Access Compliance Report

Public Rights-of-Way

(Curb Ramps)

Intersection ID: 29334	Main Street: ABERDEEN_GLEN_PL	Cross Street: BELLE_BRAGG_WY	Location:	N/A
ADA ID: B907EA58E768	Ramp Type: Perp	Initial Pass/Fail: Fail	Overall Compliance: No	Severity Score: 8.75

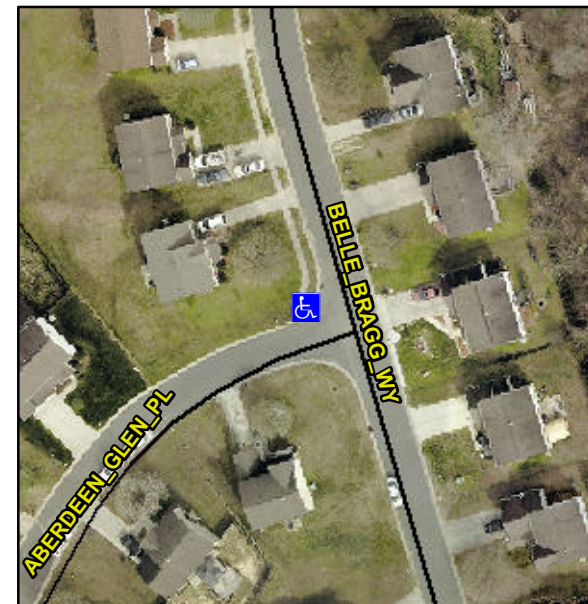
Not Found, R304.5.1

Compliance	Description	Data	Compliance	Description	Data
N/A	Ramp Length (in)	49.0	Yes	Ramp Slope (%)	5.2
No	Ramp Width (in)	47.5	Yes	Ramp XSlope (%)	0.7
N/A	Flare Type LT	N/A	N/A	Flare Type RT	N/A
N/A	Flare Slope LT (%)	N/A	N/A	Flare Slope RT (%)	N/A
N/A	Flare Traversable LT?	N/A	N/A	Flare Traversable RT?	N/A
N/A	Landing Length (in)	N/A	N/A	DWS Provided?	N/A
N/A	Landing Width (in)	N/A	N/A	DWS Contrast?	N/A
N/A	Landing Slope (%)	N/A	N/A	DWS Length (in)	N/A
N/A	Landing X Slope (%)	N/A	N/A	DWS Full Width?	N/A
N/A	Landing Curb? (Y/N)	N/A	N/A	DWS Offset (in)	N/A
N/A	Shared Landing?	N/A			
N/A	Gutter Ponding?	N/A	N/A	Gutter Slope (%)	N/A
N/A	Gutter Lip Ht (in)	N/A	N/A	Gutter X Slope (%)	N/A
N/A	Painted X Walk1?	No	N/A	Painted X Walk2?	N/A
	X Walk 1 Direction	To S		X Walk 2 Direction	N/A
N/A	X Walk 1 Width (in)	N/A	N/A	X Walk 2 Width (in)	N/A
	X Walk 1 Slope (%)	3.8		X Walk 2 Slope (%)	N/A
	X Walk 1 X Slope (%)	3.1		X Walk 2 X Slope (%)	N/A

Remove & Replace Entire Ramp.
